## MEMORANDUM

**SUBJECT:** 80 Water Street

The Division of Transportation Planning and Division of Traffic Engineering reviewed the site plans and Traffic Impact Study submitted by Bowman Consulting Group.

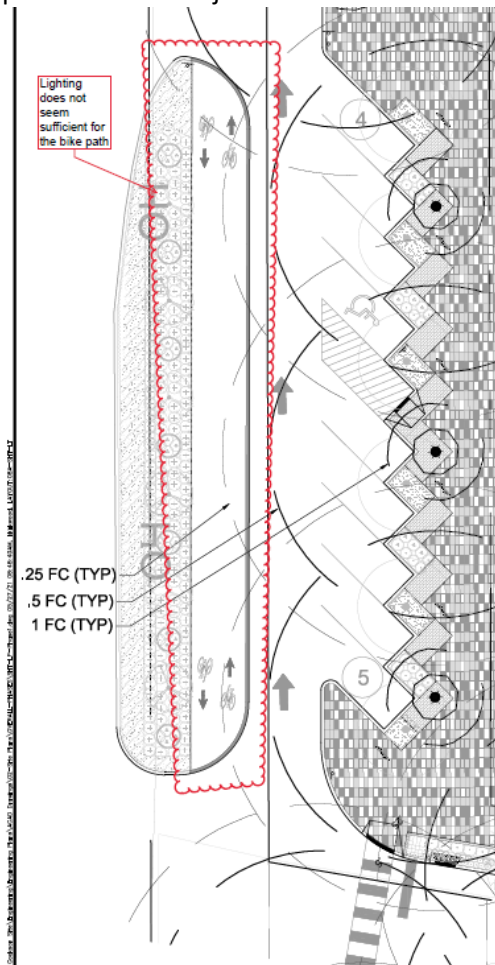
between the existing bike lanes on Mallory and Claremont east of Mallory, and the proposed 80 Water Street development.

- iii) As noted in Comment #3 below, there may be additional opportunities for bikeway treatments on streets internal to the development.
- iv) Consider shifting the Water Street bike lane to the east side of the street, between the sidewalk and proposed parking. This would be a safer configuration and provide better access to local bicycle parking, residences, and retail.
- e) Lighting Plan – the bike path north of Grant Avenue seems to have insufficient lighting in the current configuration (Sheet 8A). This would also be addressed if the bike lane shifted to a parking-protected lane adjacent to the sidewalk.

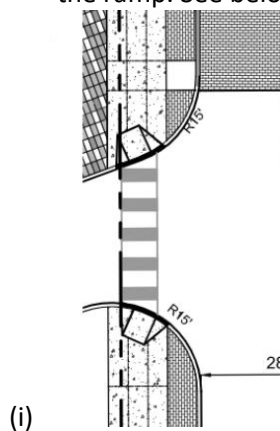
- a) Please include ADA compliant ramps and crosswalks at all intersections. This includes locations where the project site meets public right-of-way (for example, crosswalks and ADA compliant ramps should be included to cross Claremont Avenue at Water Street and at Greenwich Drive, and to cross Culver Avenue at Greenwich Drive).

- b) High-visibility (retroreflective) continental crosswalk markings should be included at all crossings, including where there are raised intersections.

(i)

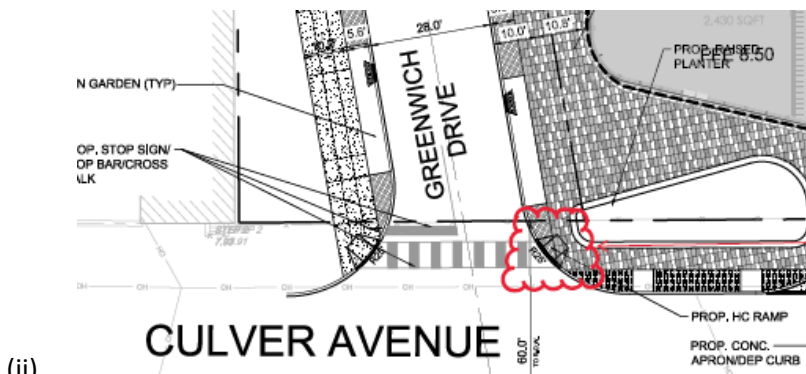
- e) The curb ramps depicted in the Civil plans do not always appear to be oriented to provide sufficient landing space fully within the crosswalk striping. Below is an example from the site plan (i).

- f) The curb ramp at the NE corner of Greenwich Drive and Culver Avenue appears to be obstructed by the location of the large planter. Please confirm appropriate space for ADA compliance at the top of the ramp. See below image on the right (ii).

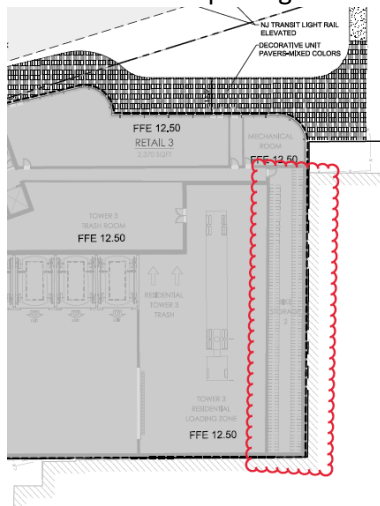
- a) The shared use path in the linear park is not of sufficient width for a mix of pedestrians and cyclists and different uses. The Bikeway Design Guide calls for a minimum of 10' and preferred width of 14' for off-street shared use paths. The current plans include a width of only 7'.
